<b>Docket Number:</b>	82-AFC-01C
<b>Project Title:</b>	Compliance - Application for Certification for PG&E Geysers Unit 20
<b>TN #:</b>	222335
<b>Document Title:</b>	Geysers Power Company, LLC - Consolidated Petition for a Staff Approved Modifications
<b>Description:</b>	FOR GEYSERS UNIT 16 (79-AFC-5C), UNIT 18 (79-AFC-3C), and UNIT 20 (82-AFC-1C)
<b>Filer:</b>	Raquel Rodriguez
<b>Organization:</b>	Geysers Power Plant
<b>Submitter Role:</b>	Applicant
<b>Submission Date:</b>	1/23/2018 10:18:08 AM
<b>Docketed Date:</b>	1/23/2018

**GEYSERS POWER COMPANY, LLC**  
**CONSOLIDATED PETITION FOR A STAFF APPROVED MODIFICATIONS**

**GPC Quicksilver Power Plant**  
**GPC Socrates Power Plant**  
**GPC Grant Power Plant**  
**Geysers Unit 16 Docket: 79-AFC-OSC**  
**Geysers Unit 18 Docket: 79-AFC-OJC**  
**Geysers Unit 20 Docket: 82-AFC-01C**

CALPINE CORPORATION		JOB NUMBER	144890	REV	△
COOLING TOWER					
FIELDWIDE UPGRADES					
UNIT 16 SITE PLAN					
FIRE PREVENTION UPGRADES		DRAWING NUMBER		16M1-1

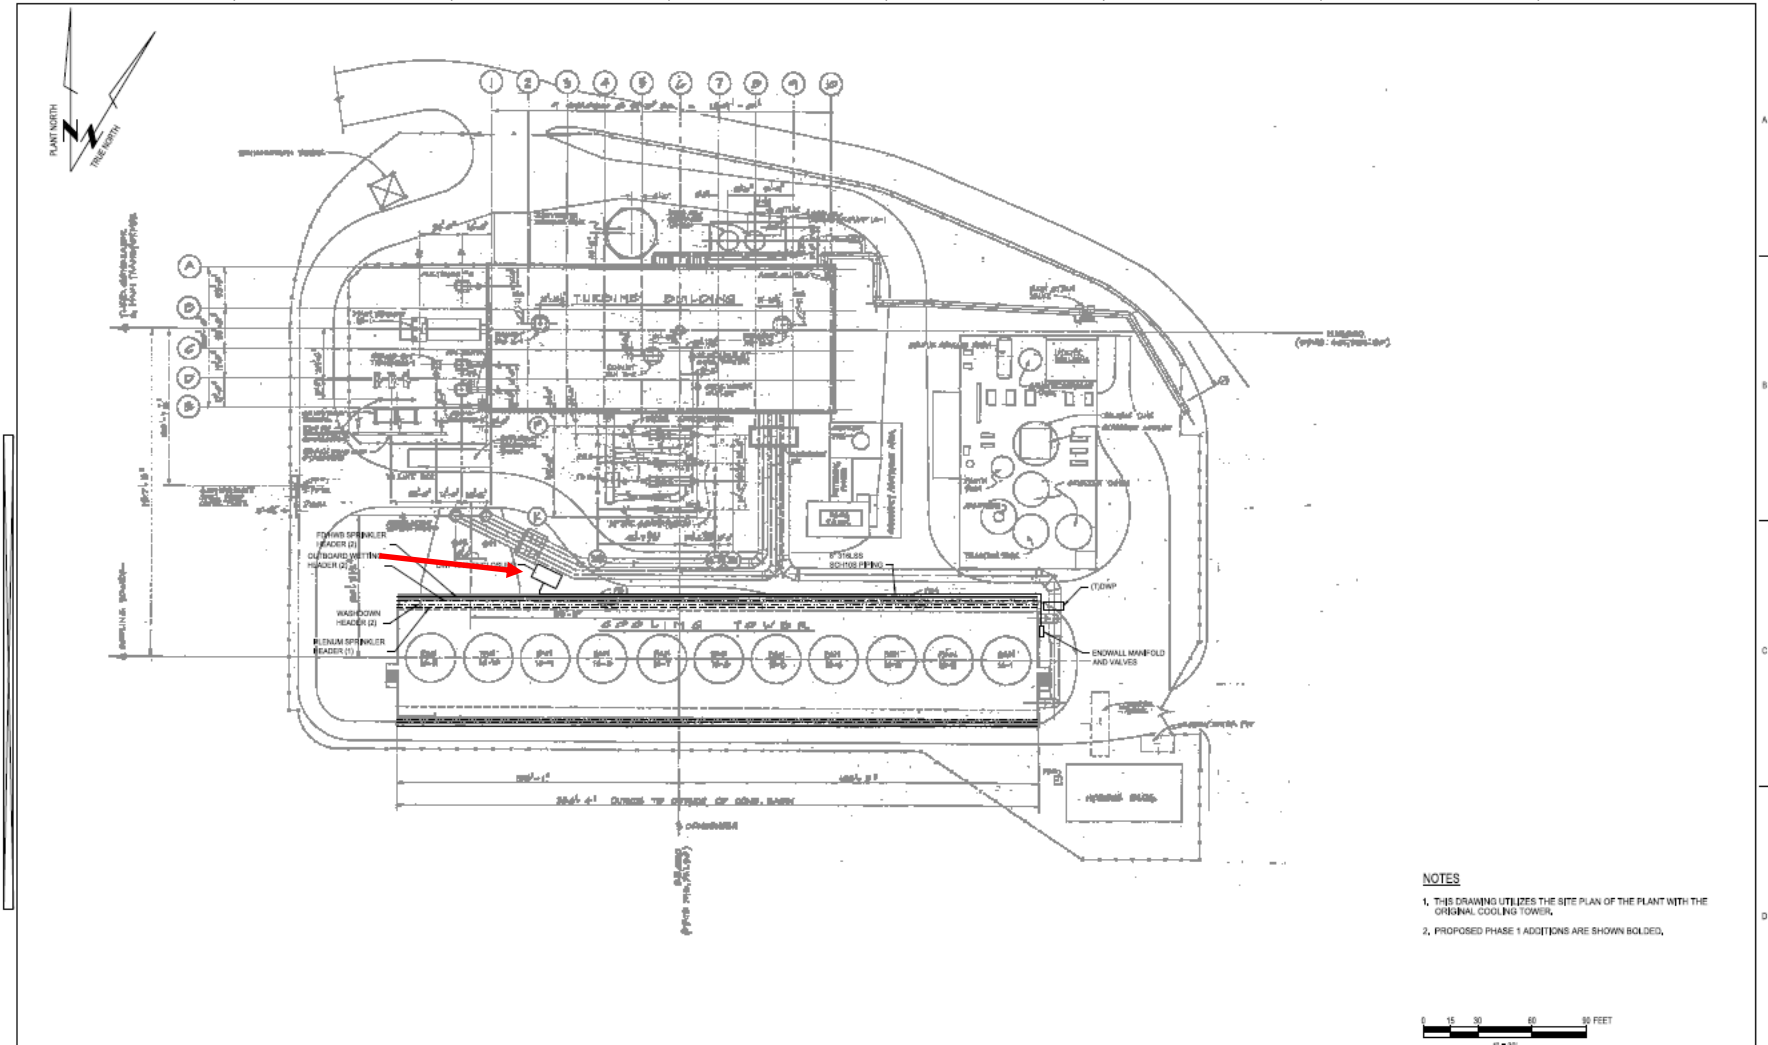
New DWP

CALPINE CORPORATION	JOB NUMBER	REV
COOLING TOWER	144892	▲
FIELDWIDE UPGRADES		
UNIT 18 SITE PLAN	DRAWING NUMBER	
FIRE PREVENTION UPGRADES	18M1-1

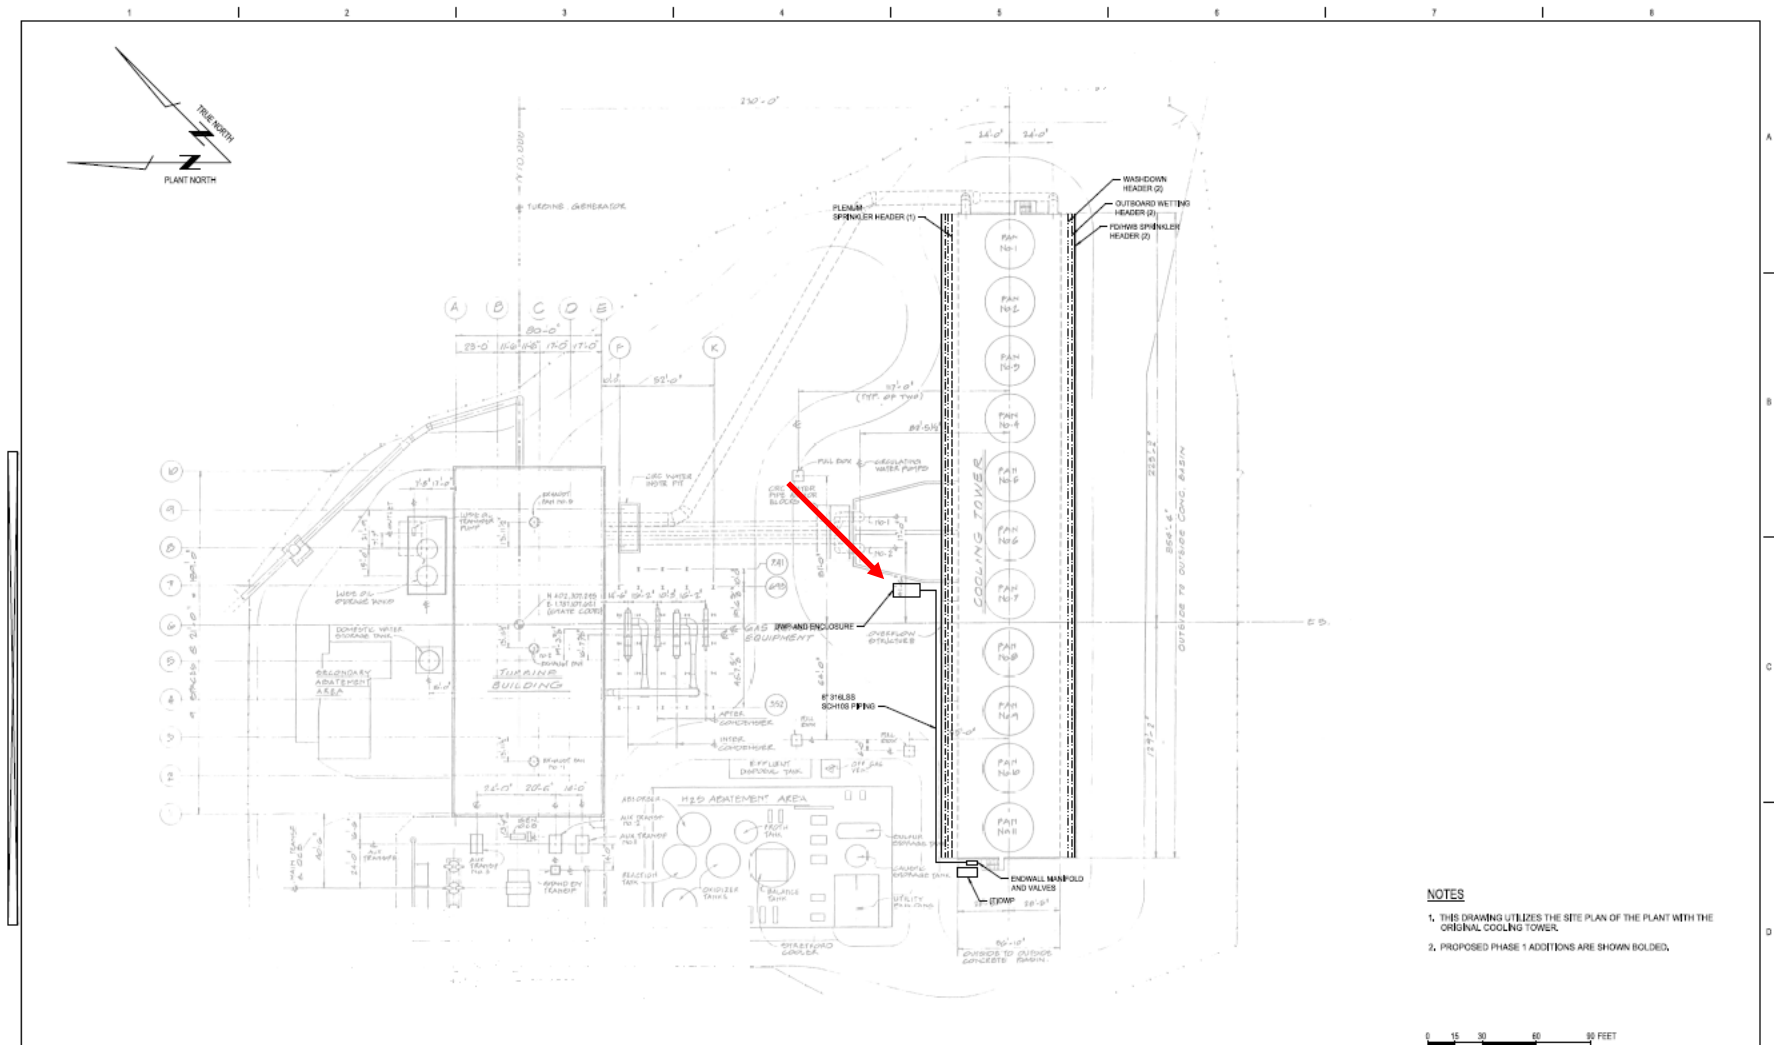
New DWP

CALPINE CORPORATION	JOB NUMBER	REV
COOLING TOWER FIELDWIDE UPGRADES	144890	△
UNIT 20 SITE PLAN FIRE PREVENTION UPGRADES	DRAWING NUMBER	
	20M1-1

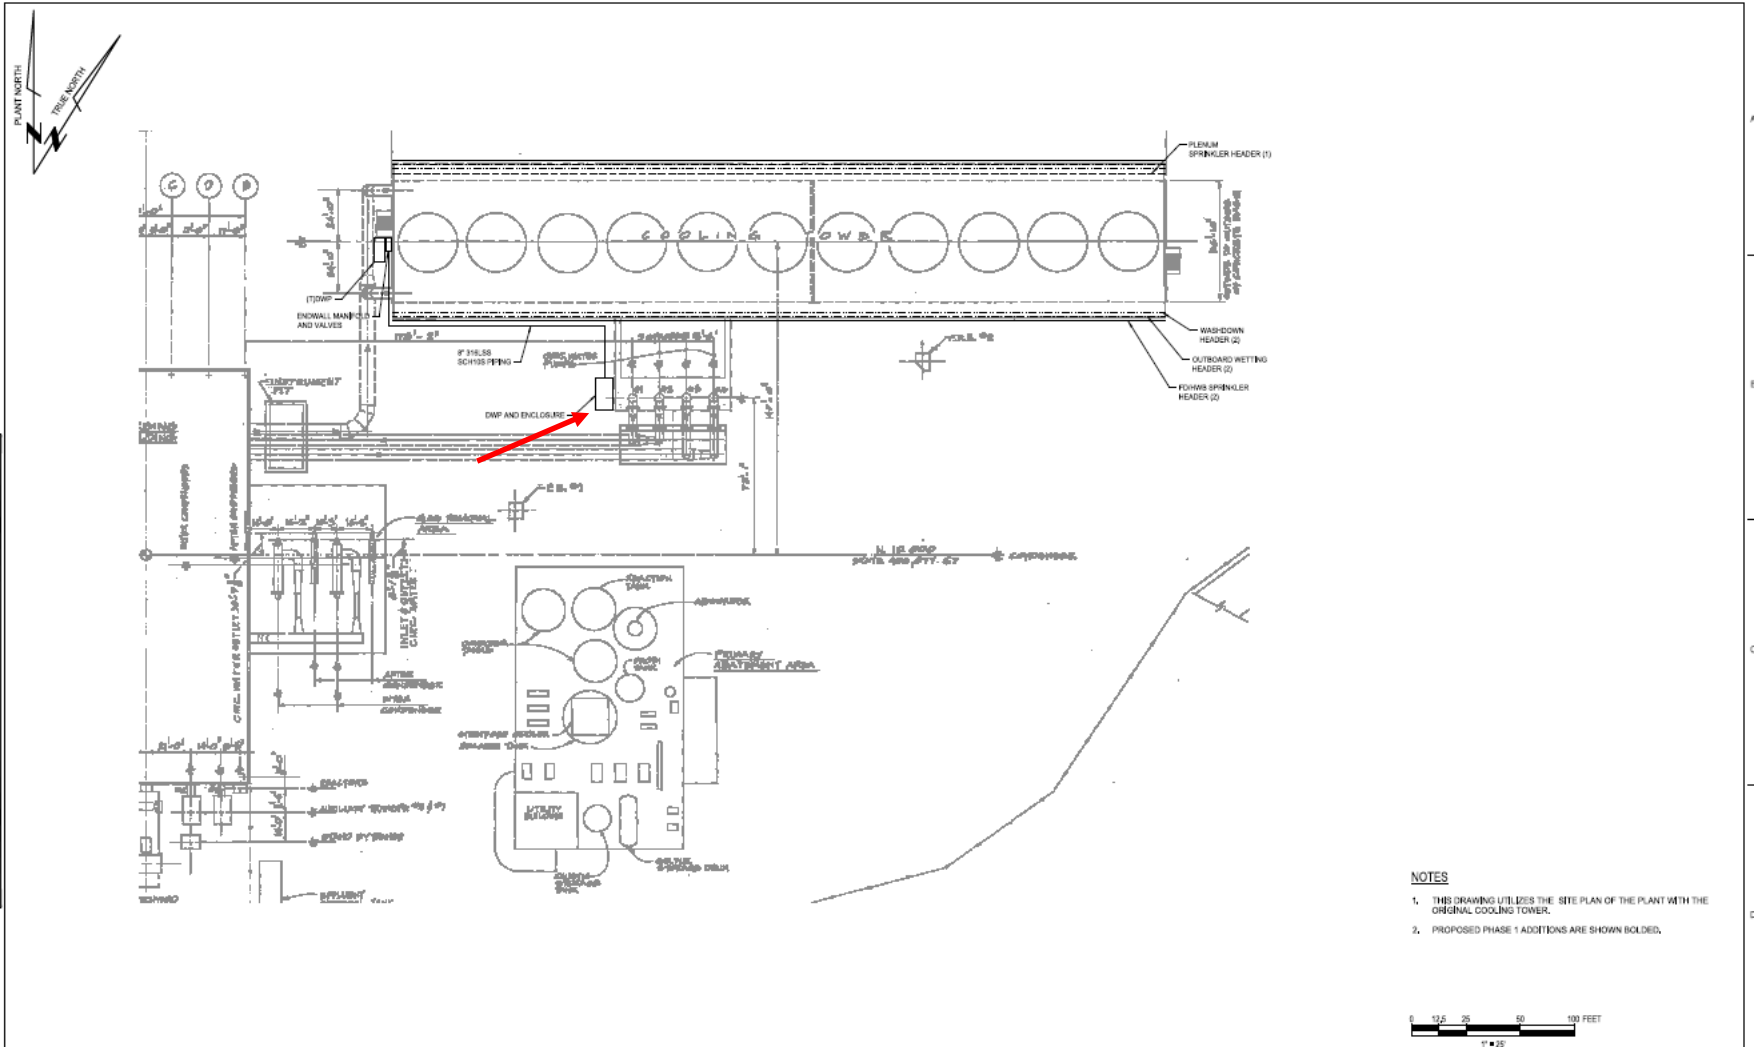
New DWP
